Service Bulletin

Subject: HESITATION / IDLE VIBRATION DUE TO CRACKED ENGINE MOUNT	Bulletin No: 01-016/10
	Last Issued: 06/16/2010

- This bulletin supersedes the previous bulletin 01-021/06 issued 6/13/06, 01-001/09 issued 01/20/09, and 01-016/10 issued 02/17/10. The APPLICABLE MODEL(S)/VINS, PART(S) INFORMATION, and WARRANTY INFORMATION have been revised.
- Changes are noted below beside the change bar in Red.

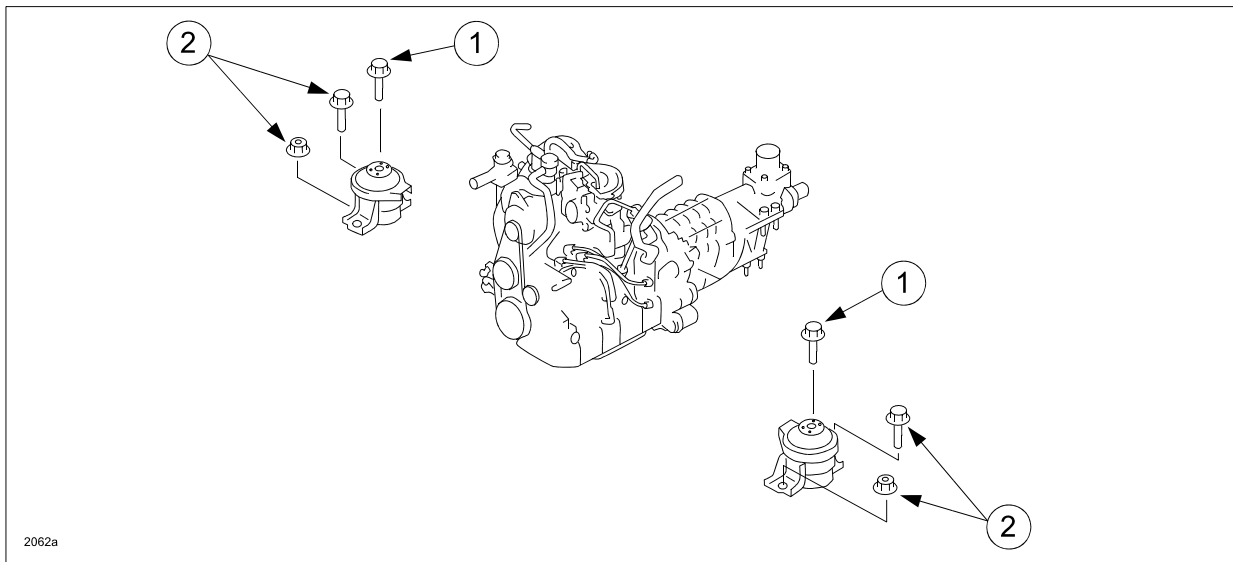
Depending on the driving condition or engine condition, the RH side engine mount rubber may deform. As a result, the RH side engine mount can crack. As a mass production change, the material of the engine mount rubber has been changed.

Customers having this concern should have their vehicle repaired using the following procedure.
